**RE: PROPOSED APPLICATION FOR RENOVATIONS AND EXTENSIONS TO A
HERITAGE HOUSE, IN A MAPPED TRADITIONAL BUILDING CHARACTER OVERLAY,
INCLUDING PARTIAL DEMOLITION
AT 124 SHERWOOD ROAD IN TOOWONG
COUNCIL REFERENCE NUMBER A007085935**

We refer to the above application and Council's Information Request dated 3 September 2026. Please find below our response to each of the items raised in this communication.

Updated proposed site plan

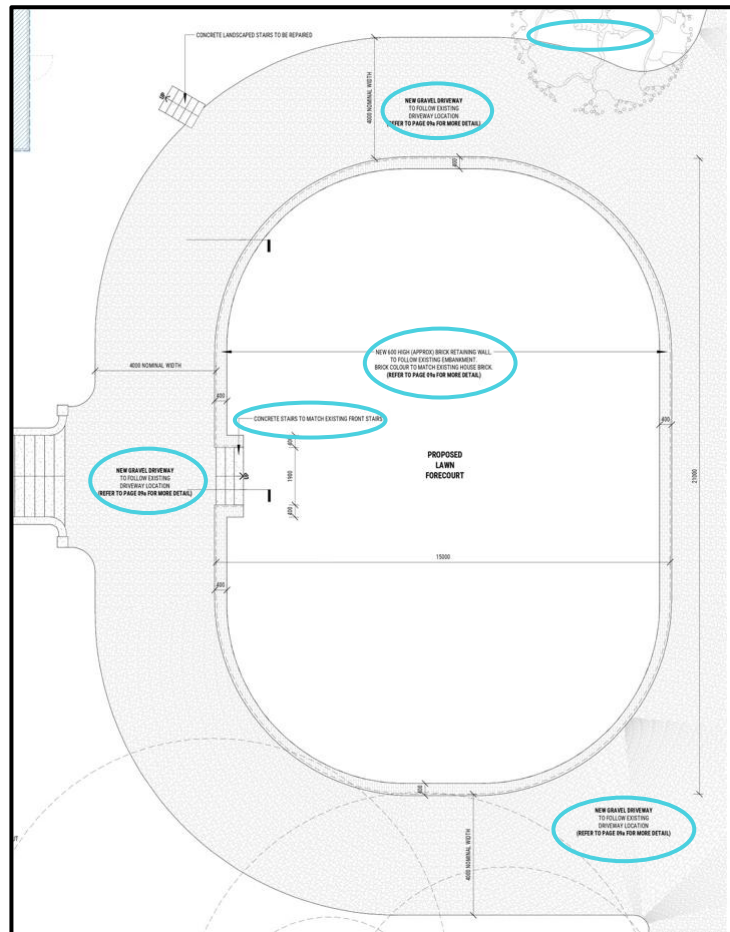
- a) The intention is to replace the existing gravel driveway with a new gravel driveway, following the same alignment. With regards to the new retaining walls, the intention is to build them out of exposed brick that visually matches the existing brick on the house, following the alignment of the embankment, and with a height of approximately 60cm. Lastly, with the stairs, the intention is to repair and retain the existing landscaped side stairs, and the new central carriageway stairs will be built out of concrete to match the existing front central house stairs.

- b) The only the new retaining wall proposed as part of this application will be located along the inside edge of the circular driveway. As noted above, the intention is to build this out of exposed brick, following the alignment of the embankment and with a height of approximately 60cm.

- c) We confirm that the proposed granite gravel driveway will be mid-grey in colour, while the brick colour will match the existing brick on the house.

- d) The intention is to retain the existing vegetation on the site. Noting the driveway works will use the same permeable materials, in the same alignment, ensure that there are no adverse impacts on this vegetation

As shown via the aqua circles on the images over the page, the proposed site and upper floor plans have been updated, and a new "driveway and forecourt details" page has been added, to confirm the information above.

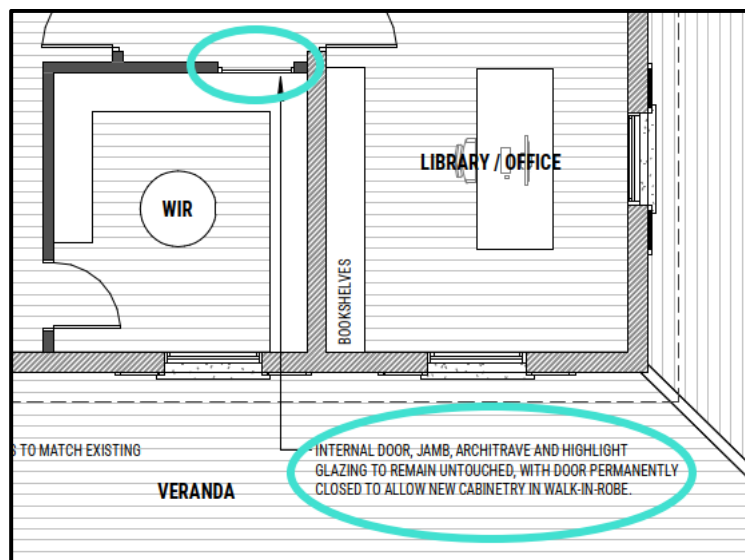
In response to item 2 of Council's request, please refer to page 13 of 14 of the enclosed amended proposal plans.

This page has been updated to include a skylight detail insert (as shown below for ease of reference), to provide the additional information requested.

Equal length yellow arrows = Proportionately spaced windows.
Blue arrows = Disproportionately spaced windows.

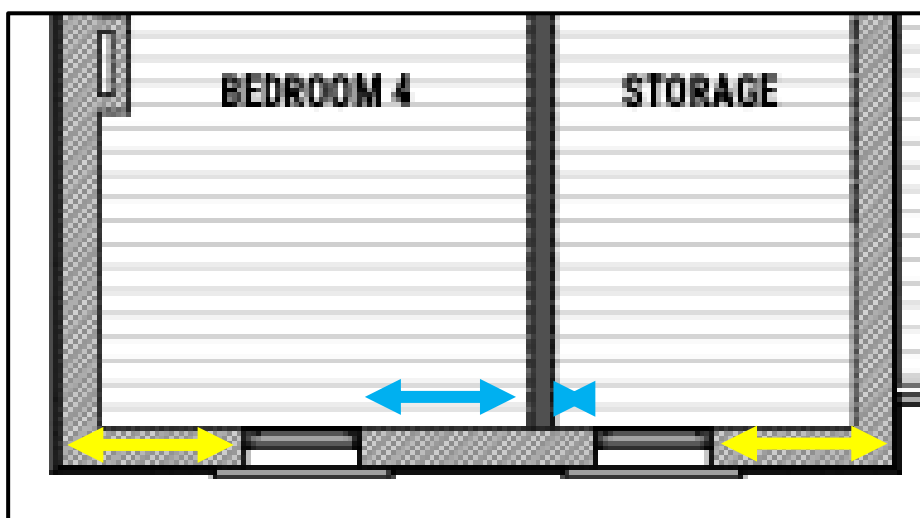
As shown by the images below, the 2 southern windows are proportionately positioned off the ends of the external walls. However, the current dividing wall between the storage room and bedroom 4, is off-centre to the windows.

It is standard for windows to be centred on rooms for this period, which was the biggest sign that the wall was added later.

Further, it is noted that the ceiling (including the edging around the dividing wall) is finished with an Art Deco-style cornice. This suggests that the dividing wall was added after 1910.

In light of the above information, we respectfully request that Council reconsider the proposed removal of this dividing wall.

5a – Rear verandah – Cast iron post

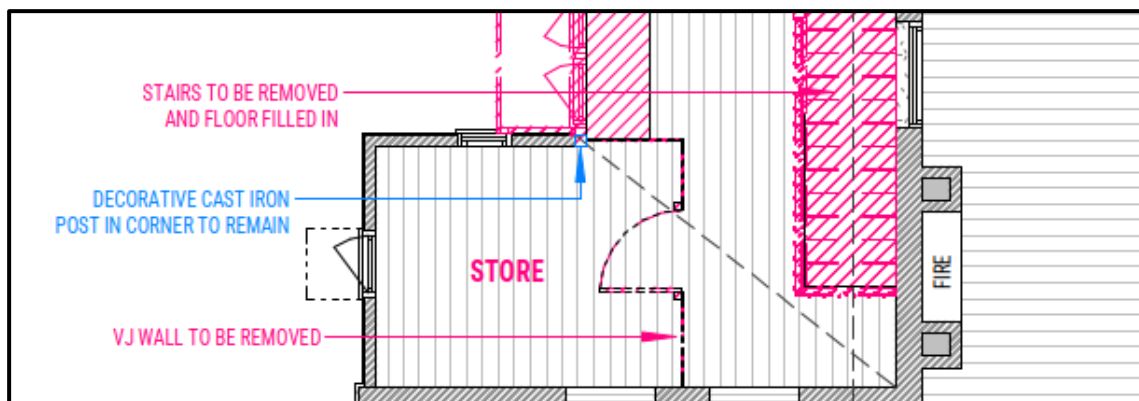
The proposal has been updated to allow for the retention of the cast iron verandah post identified in item 5a of Council's request. Please refer to the blue notation in the image below, for confirmation of this change.

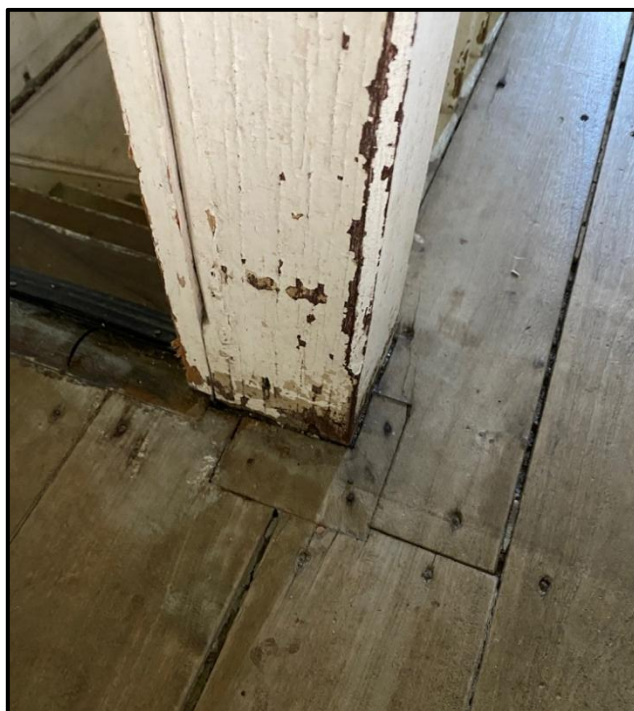
It is noted that the existing rear stairs have a taller riser (step height) and a narrow going (tread depth) than normal. As a result, they feel unnaturally steep and unnerving to walk down. Meaning that you end up almost walking down diagonally or sideways, whilst holding onto the rail, to ensure you don't slip down the stairs.

Given the safety issues associated with the current stair design, the client would like to pursue the replacement of these stairs.

Note the patch mark in the flooring

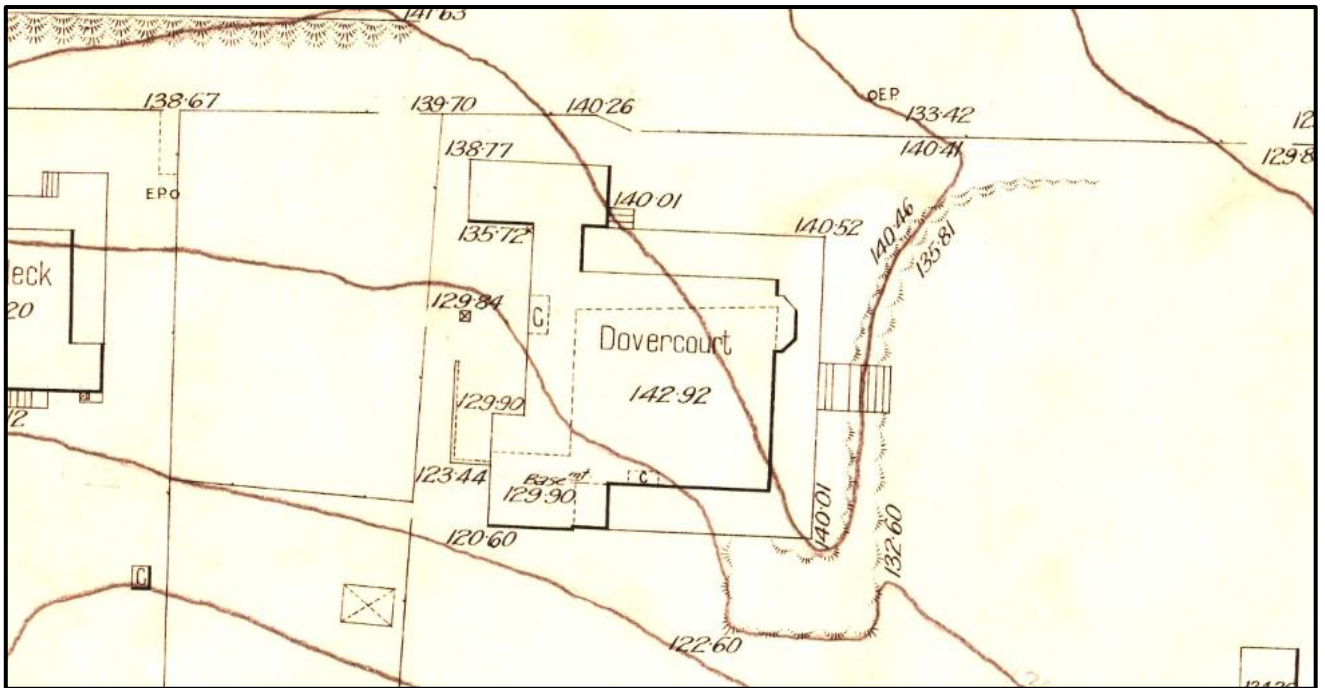
Unfortunately, the age of the stairs is unknown. However, the photo below shows signs of changes, and it is also noted that these stairs are not visible on the 1928 detail plan.

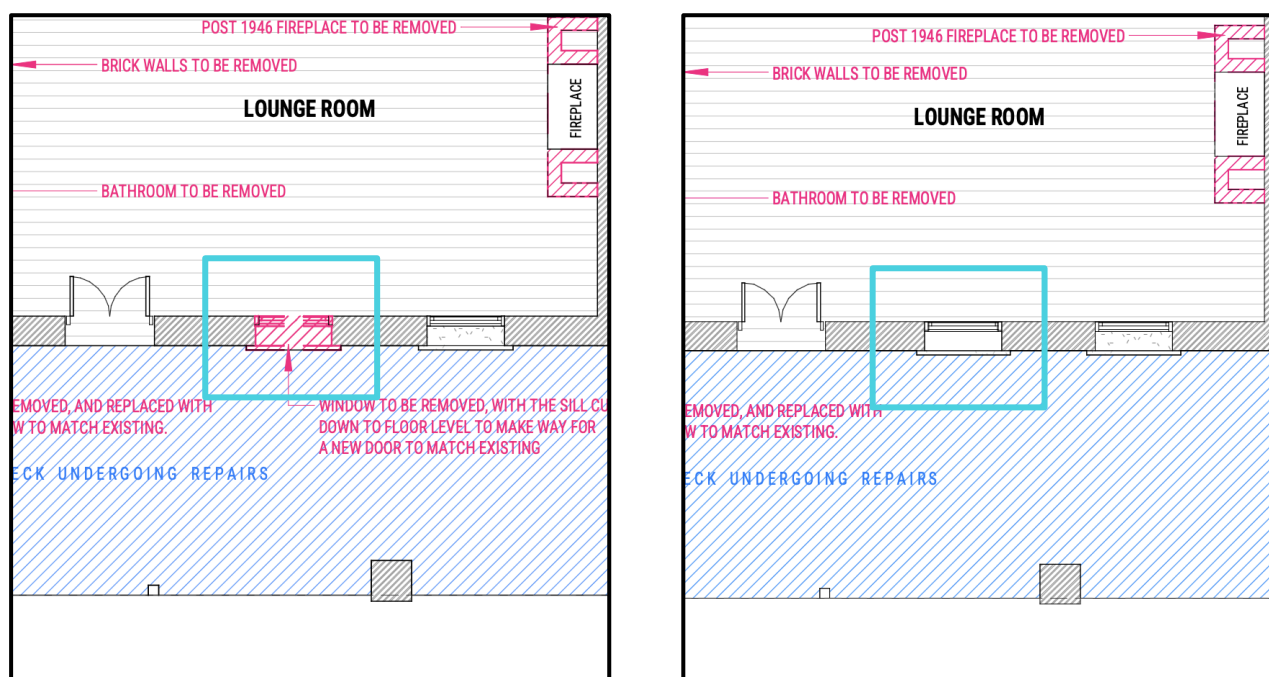
Rather, the pyramid roof form, tin and brick materiality, wrought iron balustrade, wraparound verandah, chimneys, and floor-to-ceiling sash windows, are the integral features for this house/period.

This means that the removal of these rear stairs will not impact on the ability of the site to continue to present as a late 1800s Victorian dwelling.

The fact that they aren't integral features, the fact that they could be later additions, and the fact that they are not visible from outside the property, means that their removal will not have an adverse impact on the aesthetic value of the house.
